PRESIDENT'S OFFICE SUITE ALTERATIONS		505 RAMAPO VALLEY ROAD MAHWAH, NJ 07430 RCN PROJECT NO. 2014-24-03C PROJECT NO. 94-14-002	
REV	DATE	DESCRIPTION	
-	5/1/15	OWNER REVIEW SET	
-	12/01/15	ISSUED FOR BID	
Δ	1/28/16	ADDENDUM #2	
DRAWING TITLE			
ENLARGED PLAN, INTERIOR ELEVATIONS AND SCHEDULES

RAMAPO COLLEGE
OF NEW JERSEY

PRESIDENT'S
OFFICE SUITE
ALTERATIONS

A8.0

TOILET ROOM - ENLARGED PLAN AND ELEVATIONS

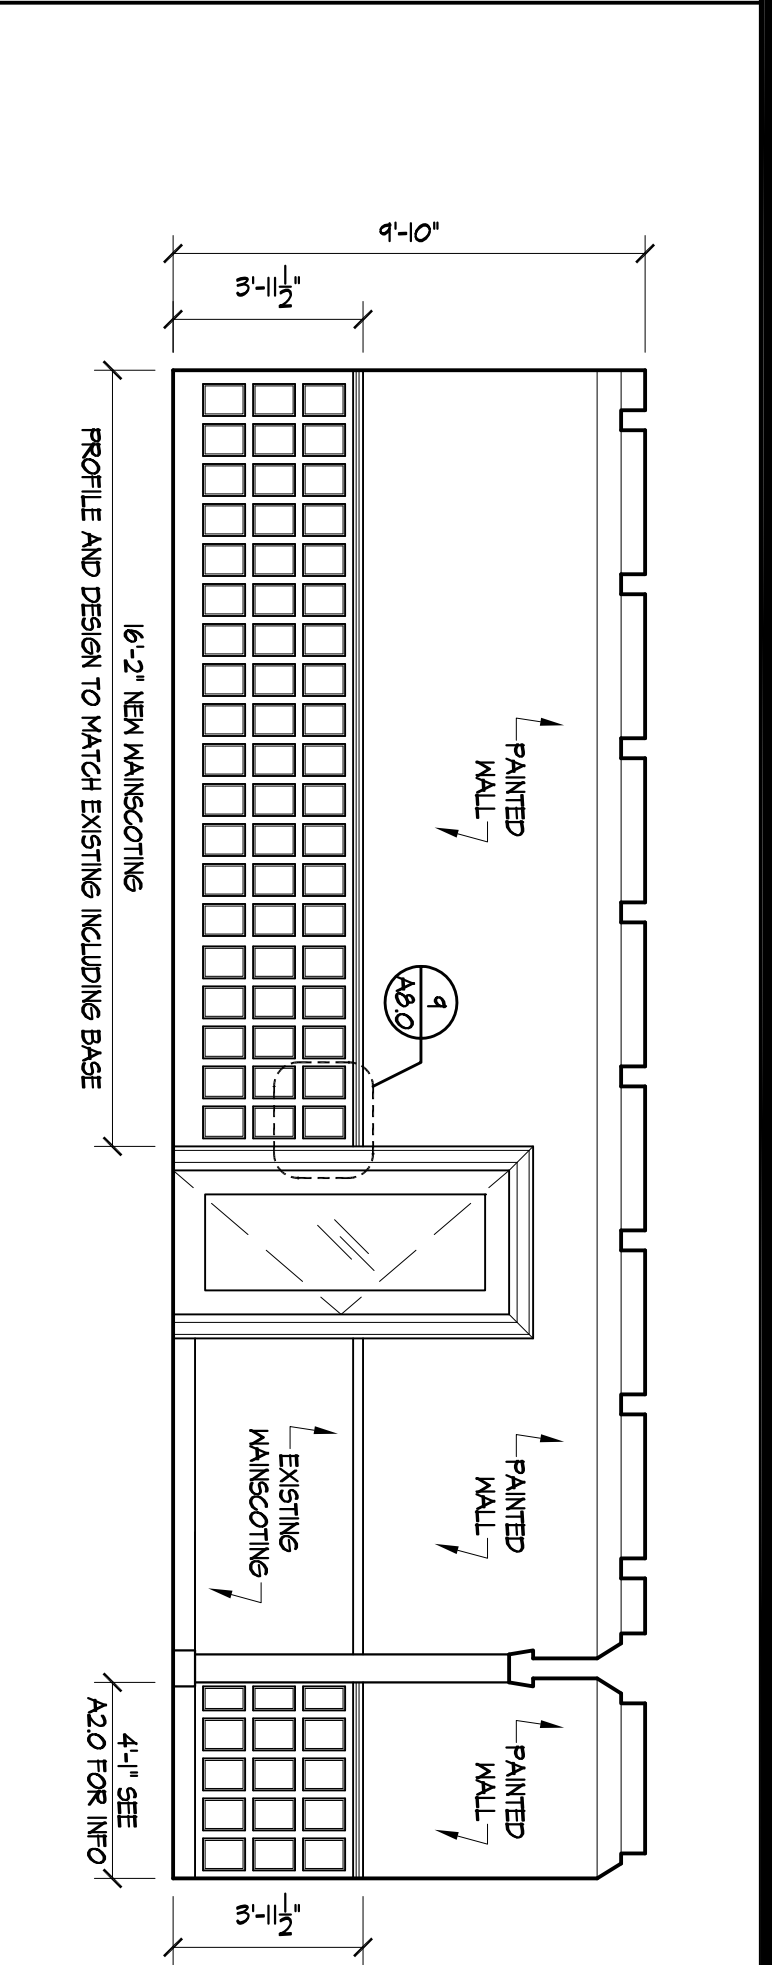
SEE Q & A QUESTION #1
